Report: TAB REPORT
Function: Test, Adjust, & Balance
Date: 01/30/2026
Completed By: National TAB

PROJECT
01-26-26 WAWA #7219 LIMA, OH

Table Of Contents

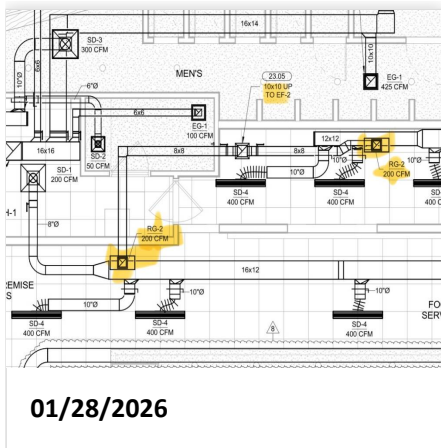
Issue Name : EF-2 LOW FLOW
Description : EF-2 is exhausting 120cfm out of 400cfm required by design. Low exhaust grille readings likely due to detached ductwork pictured.
Created By : National TAB **Assigned To :** National TAB - Noah Stafford
Status : Closed
Priority : High **Asset Tag :**
Originated Date : 01/29/2026 - Noah Stafford - National TAB

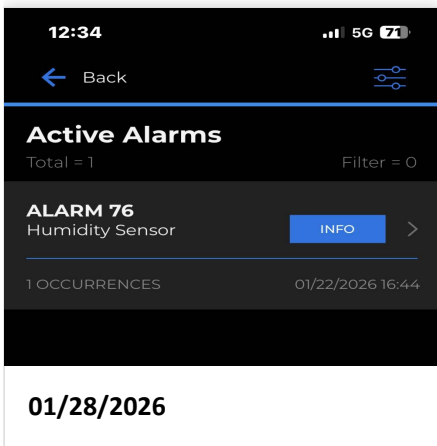
Issue Name : RTU-1 RETURN DUCTWORK
Description : Return grill 1-3 disconnected. Return grill 1-2 not ducted. TAB cannot be completed until resolved.
Created By : National TAB **Assigned To :** National TAB - Noah Stafford
Status : Closed
Priority : Urgent **Asset Tag :**
Originated Date : 01/27/2026 - Noah Stafford - National TAB

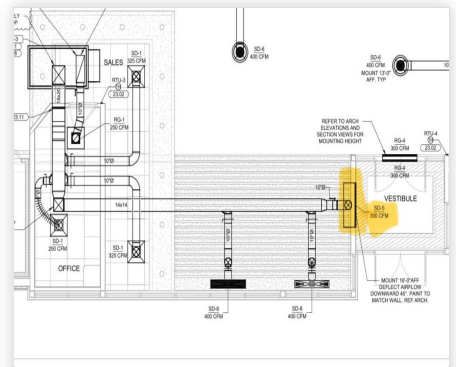
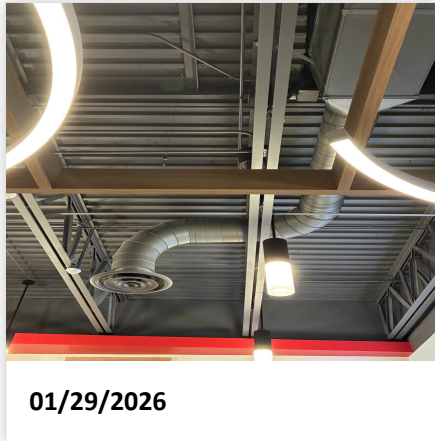
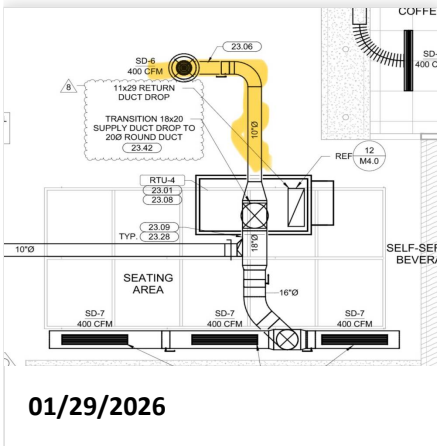
Issue Name : RTU-3 MISSING DIFFUSER
Description : RTU-3 is missing diffuser 3-1 at the main entrance vestibule. TAB cannot be completed until installed.
Created By : National TAB **Assigned To :** National TAB - Noah Stafford
Status : Closed
Priority : Urgent **Asset Tag :**
Originated Date : 01/28/2026 - Noah Stafford - National TAB
